BURLINGTON DEVELOPMENT REVIEW BOARD

Tuesday September 16, 2014

To: Development Review Board
From: Mary O'Neil, AICP, Senior Planner
Date: September 16, 2014
RE: ZP15-0249CA/CU; 19 Fletcher Place

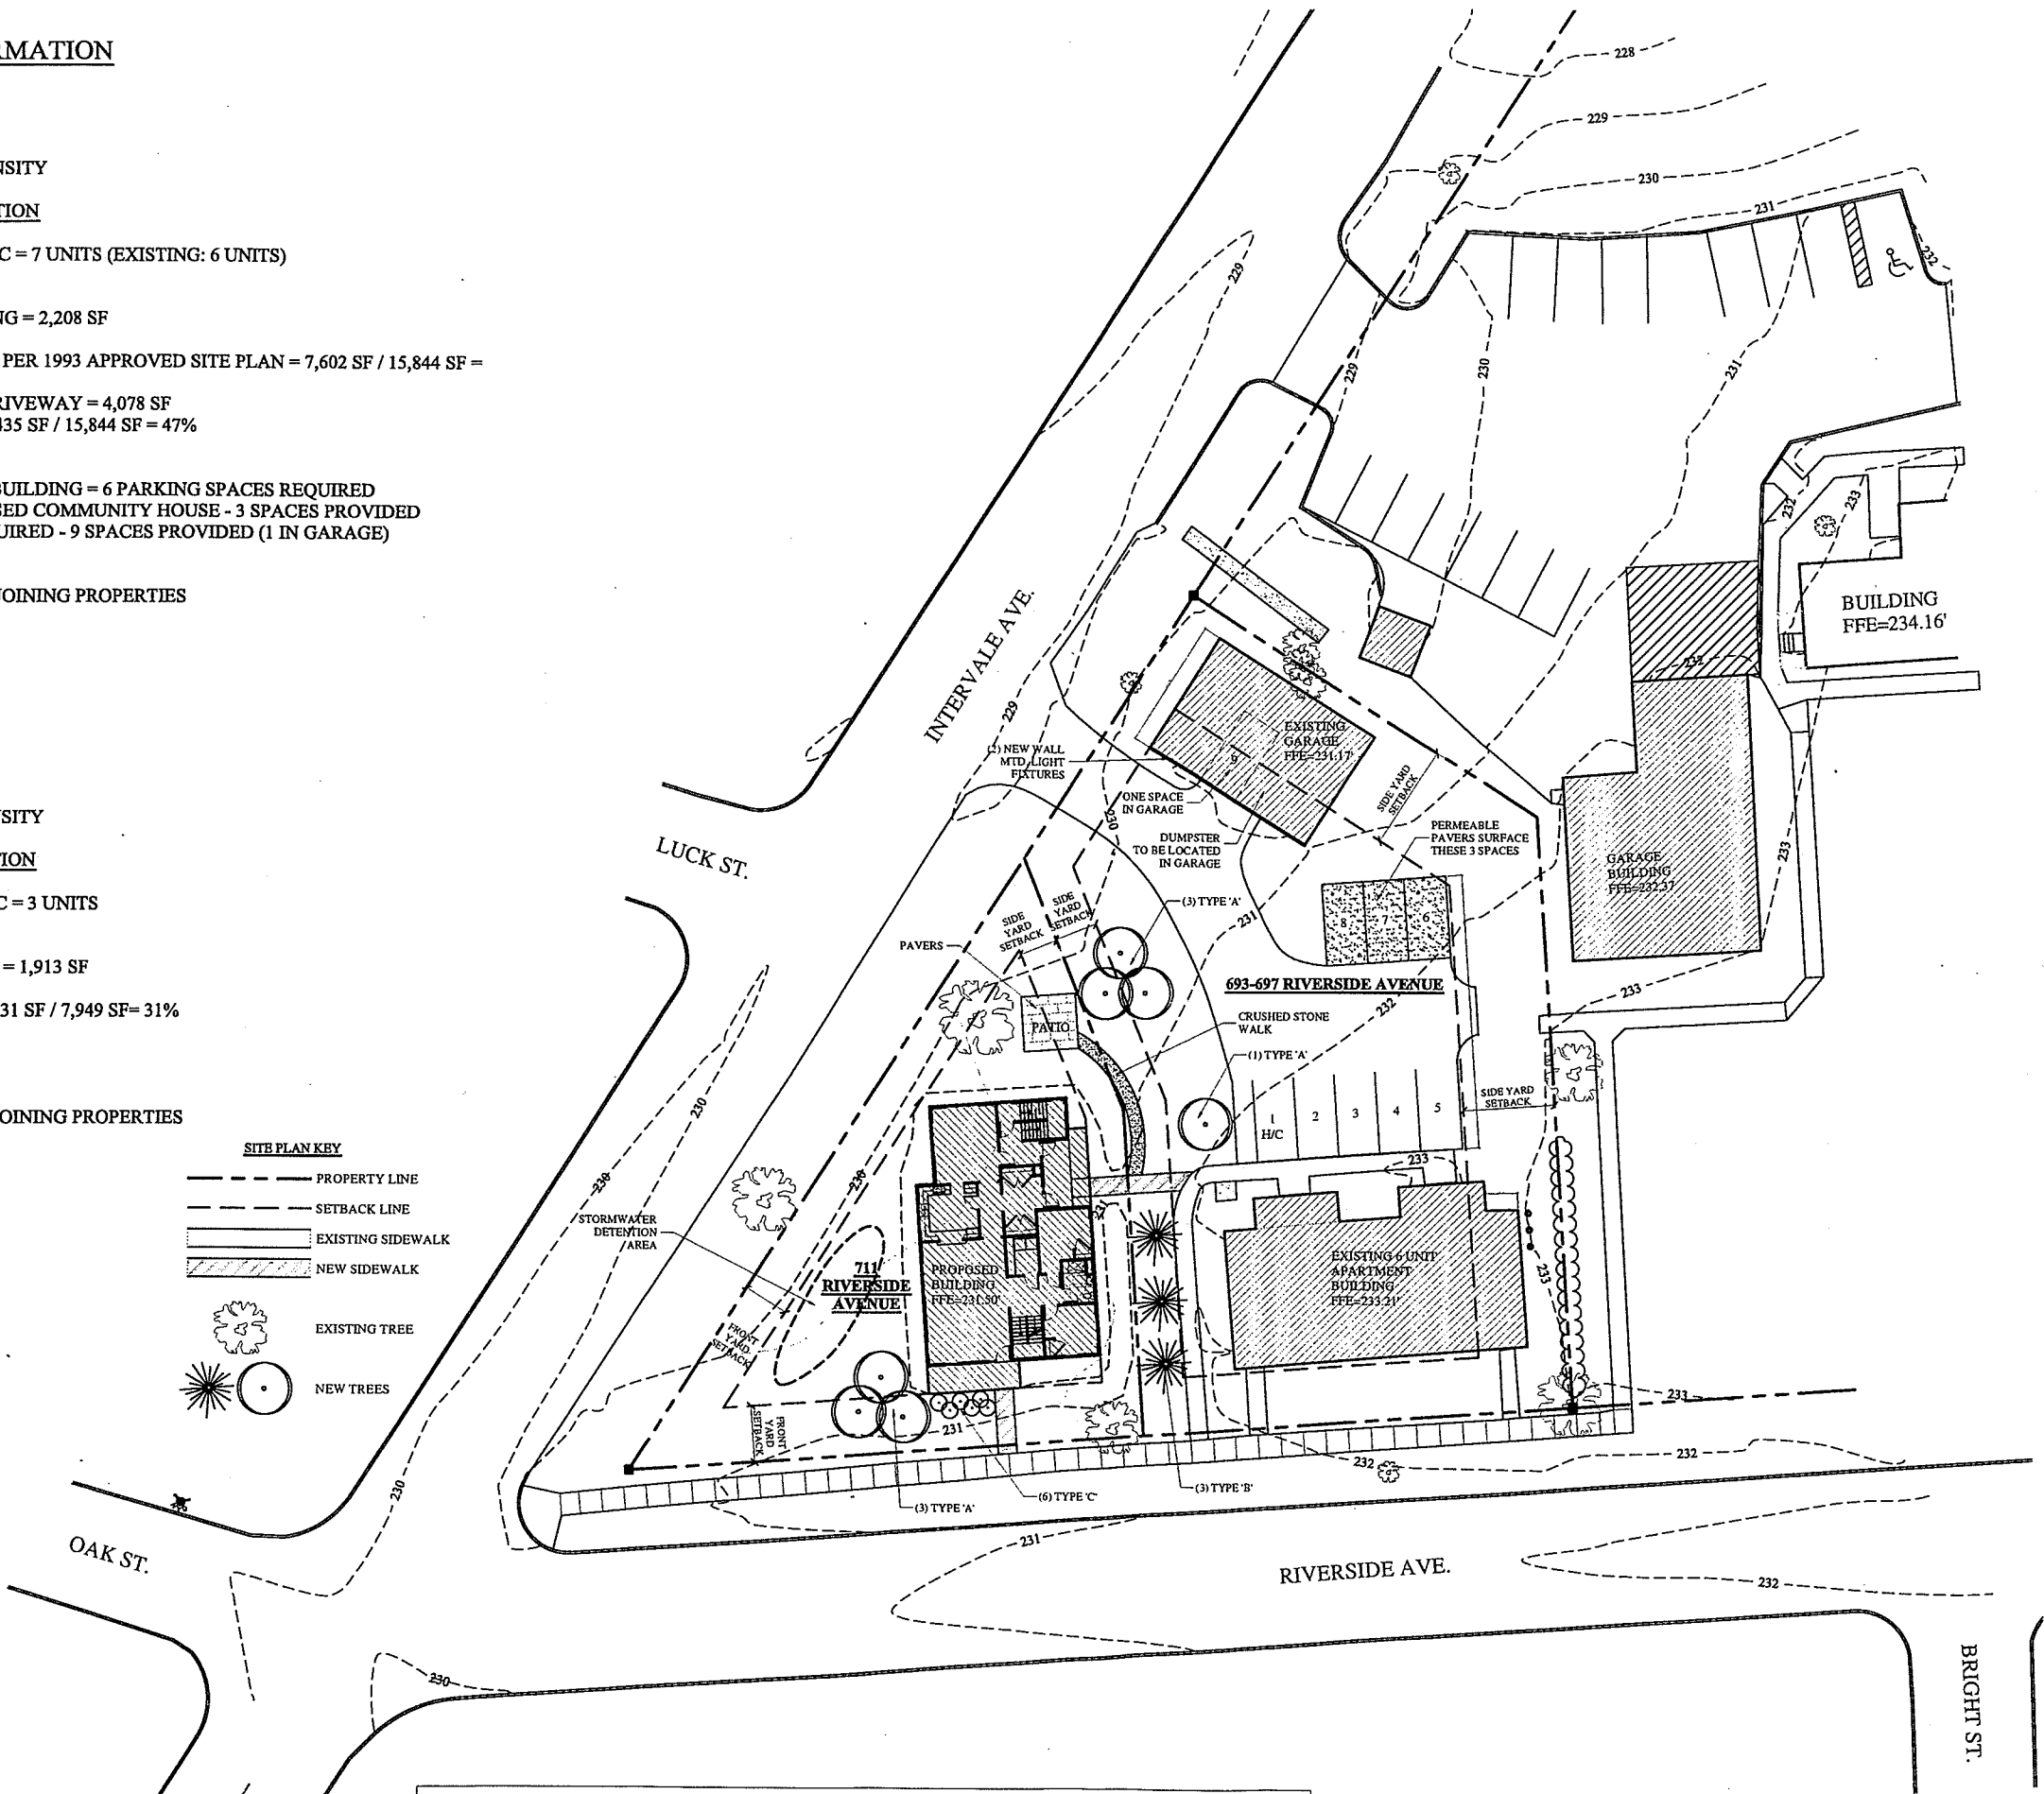
1. Trash/recyclable handling in the garage.
2. The parking spaces to be used for the community house must be dedicated by a permanent legal instrument to assure that they will remain committed to the subject property in perpetuity. Sign to be included designating 2 parking spaces for the project.
3. Utility meter location and screening – preferably on the east side of the building.
4. Written approval of the Erosion Prevention and Sediment Control (EPSC) Plan will need to be obtained from the City Stormwater Administrator.
5. Bicycle parking should be provided to some extent, possibly in the adjacent garage. There are storage rooms in basement that could be used for long-term bike storage, but requires negotiating stairs. No exterior short-term bike racks are shown and should be provided.

As noted above, utility meter locations need to be identified and should be located on the side of the building. No exterior mechanical equipment is included in the project plans. Trash handling also needs to be addressed as recommended by the Design Advisory Board. **(Affirmative finding as conditioned)**

PROPOSED SITE PLAN - PHASE 1
SCALE: As Indicated

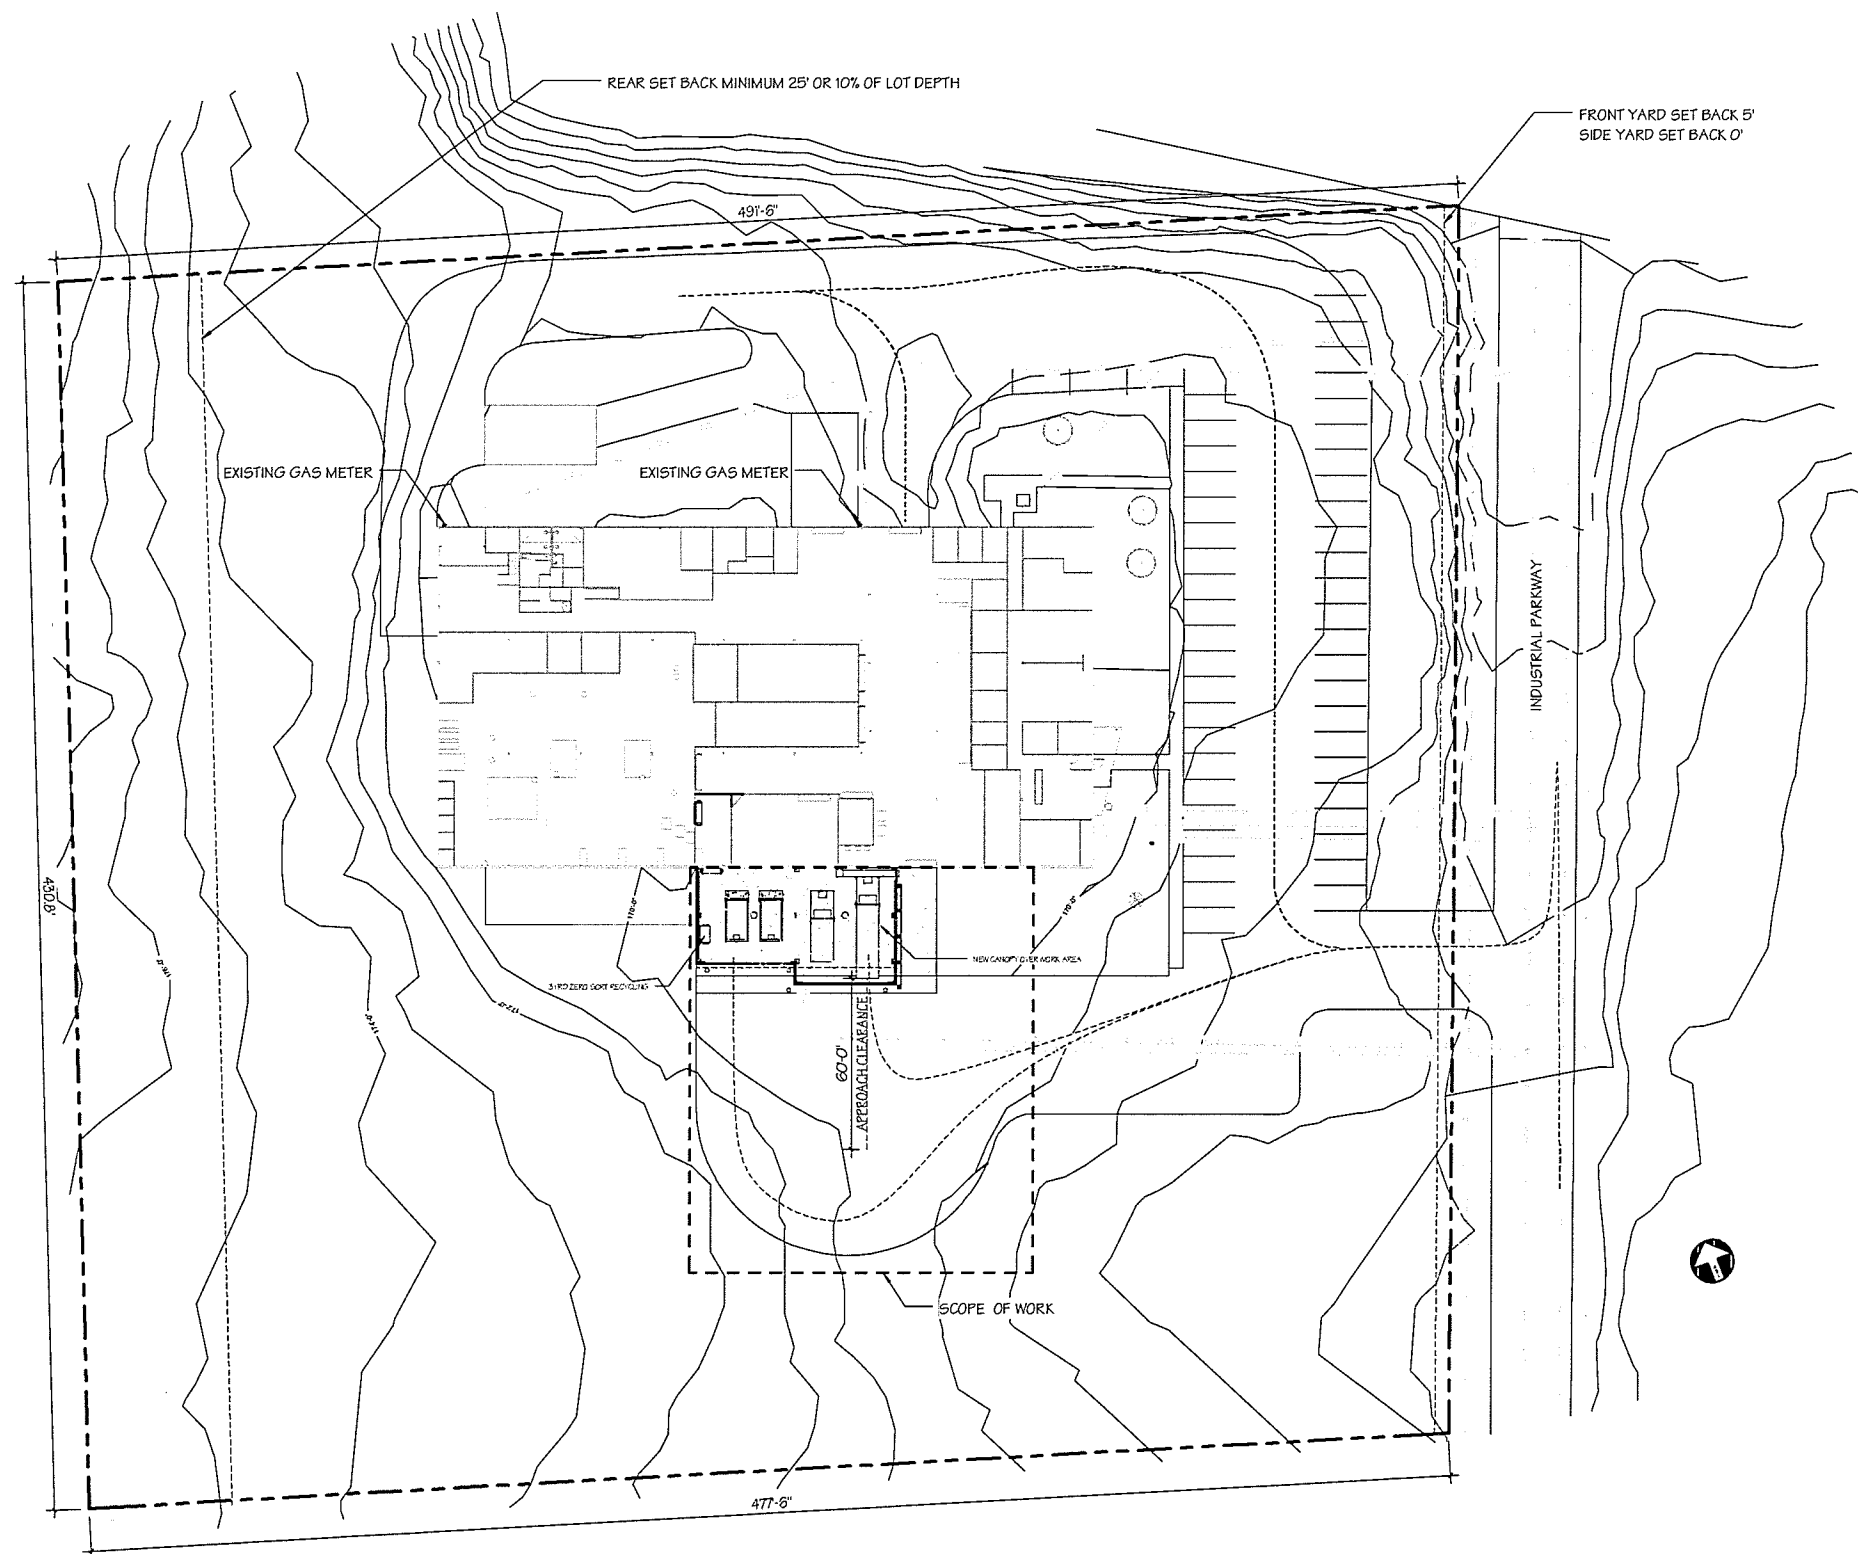
Much of the area for the additional pavement for trucks to access the new enclosure is presently mowed lawn. Some trees, however, will also be removed. The extent of tree clearing is not indicated on the site plan and must be. **(Affirmative finding as conditioned)**

1. **Prior to the release of the zoning permit**, a revised site plan depicting the limits of proposed tree clearing and new landscaping consisting of trees and shrubs alongside the east elevation of the proposed enclosure shall be submitted, subject to staff review and approval.

SITE PLAN • OPT 4

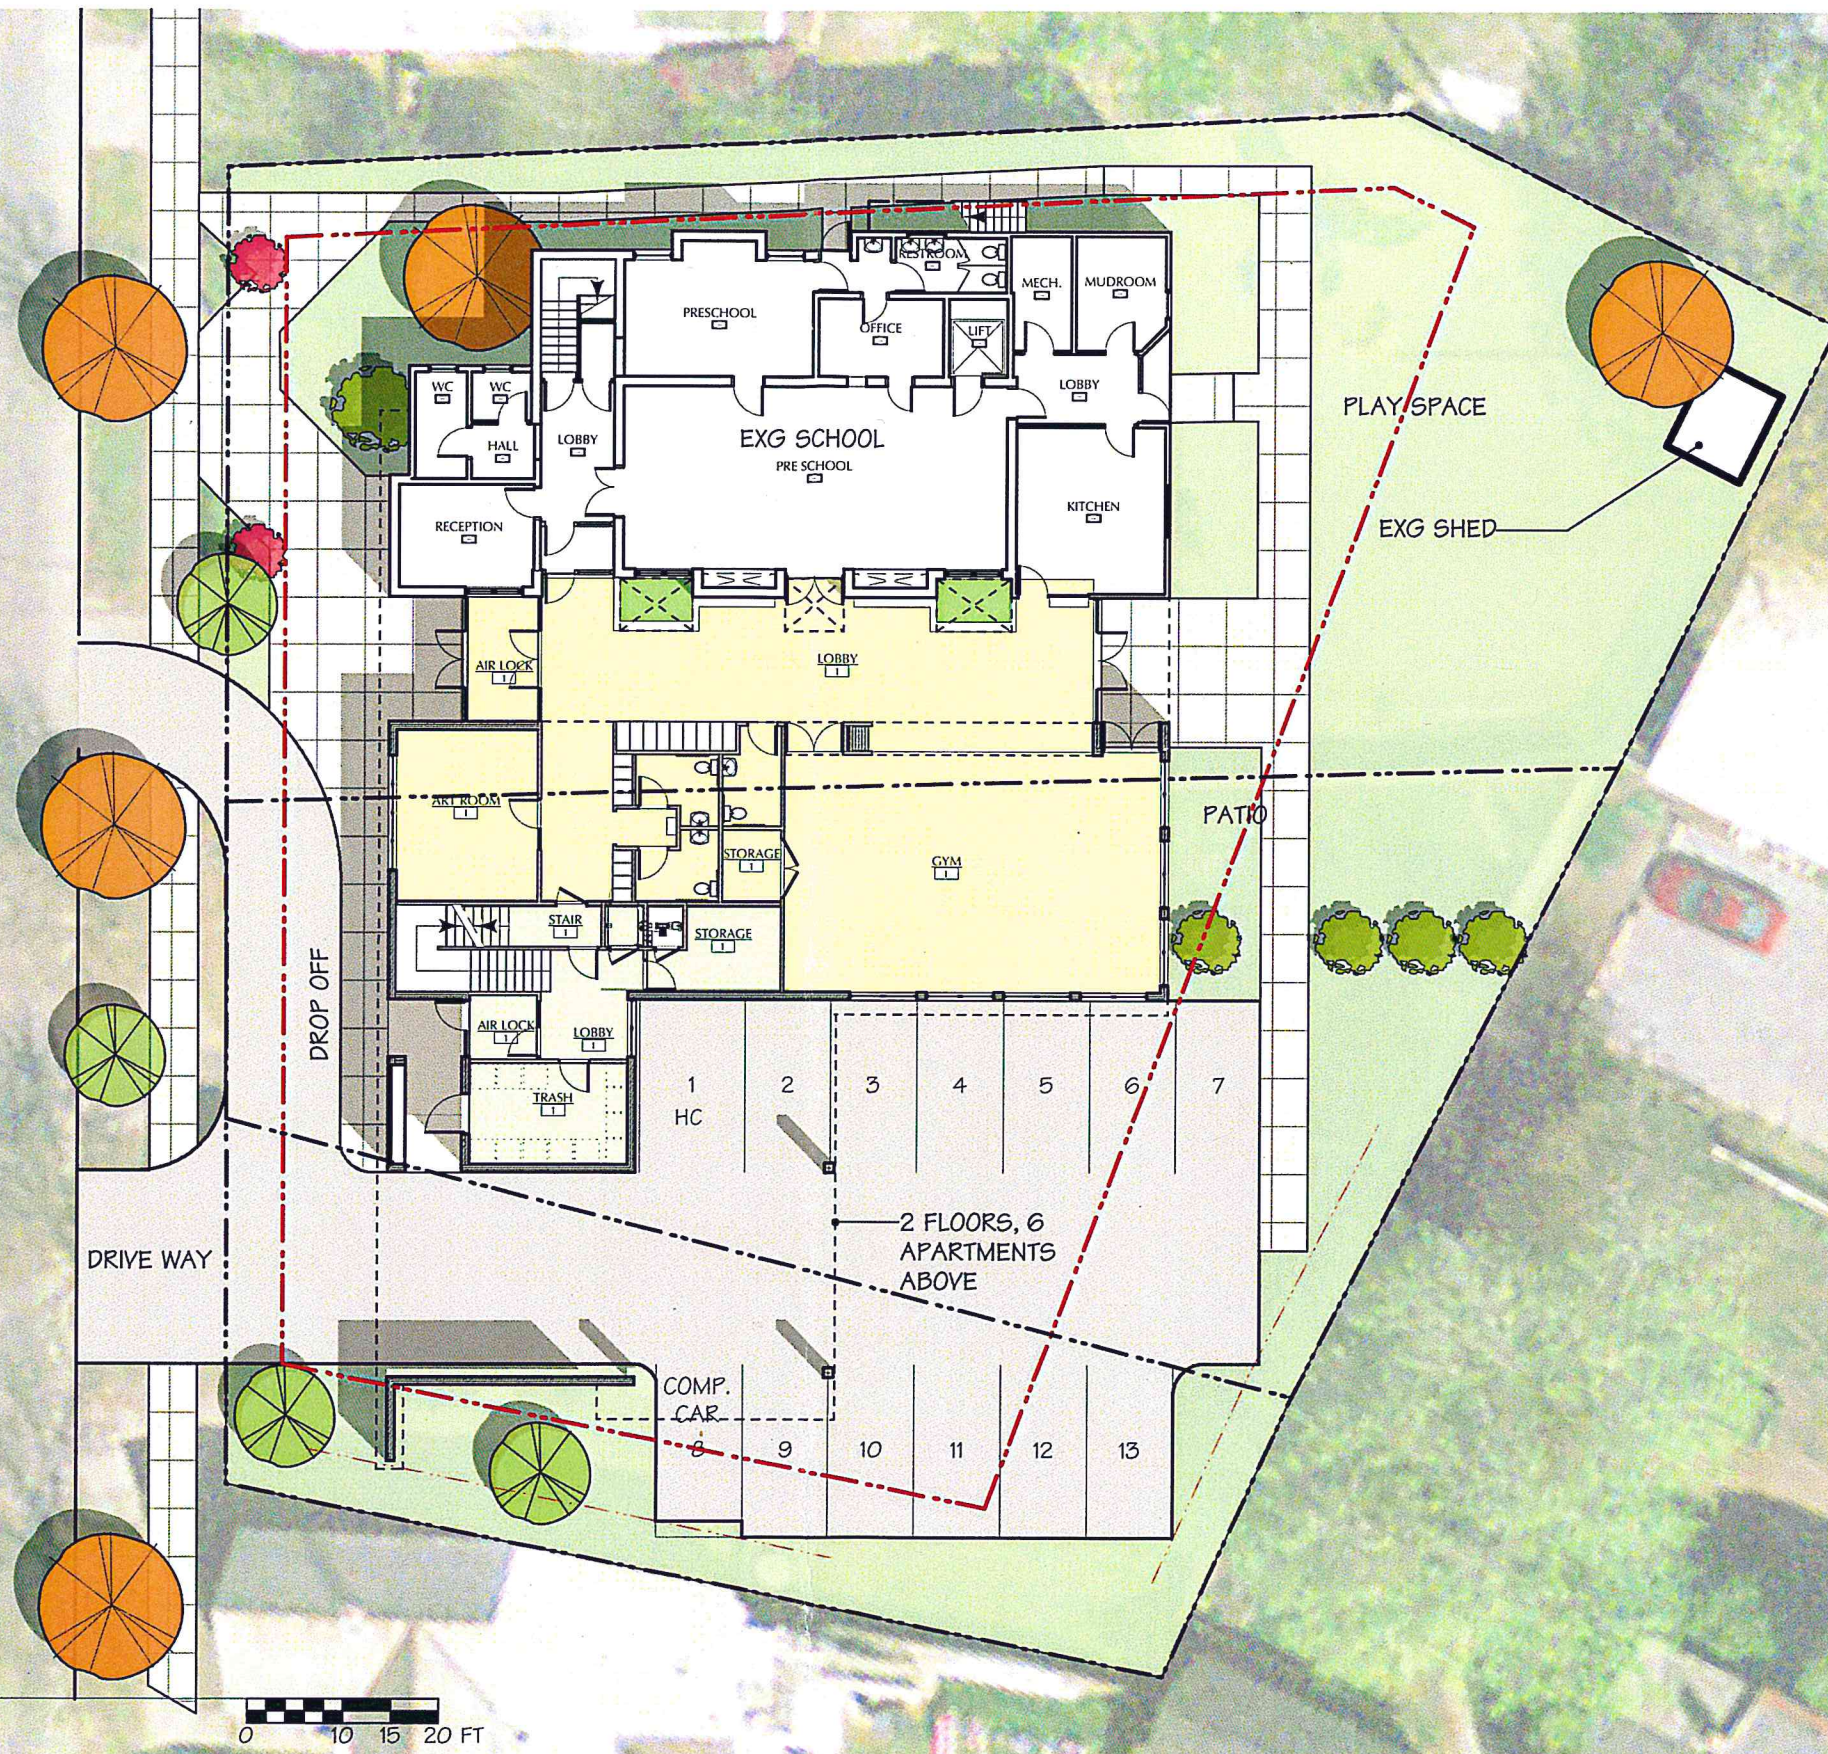
Total parking provided is 13 spaces, which will require a parking waiver. In order to support the waiver the applicant proposes that the apartment tenants will be required to remove their cars during business hours, which will leave all 13 spaces available for the Center's use. This more than doubles the amount of parking currently available to the Center on its current site.

No outside storage areas are proposed, nor do the plans show any ground-mounted mechanical equipment, although there is an interior mechanical room. No dedicated loading areas are proposed either. Utilities need to be depicted and all new utility lines must be buried.

A 39% parking waiver is needed. A specific parking management plan has not been provided other than stating that the apartment tenants will be required to remove their cars during business hours. Once requested a parking waiver conceptually is acceptable primarily due to the Center's use of alternative modes of transportation, and a demonstrated history of minimal parking needs due to the project supporting youth activities.

1. Setbacks for the proposed lot line adjustment and new construction must be verified for compliance with dimensional requirements.
2. The applicant shall receive written verification of adequate wastewater capacity from the Department of Public Works.
3. Any traffic related information requested by the Department of Public Works shall be provided.
4. An outdoor lighting plan shall be submitted. The lighting plan shall depict all proposed fixture types. The photometric plan shall tabulate for the front, parking and entryway, walkways with minimum, maximum, and average illumination levels tabulated. The same shall be done for the back yard play area if applicable. The number and placement of
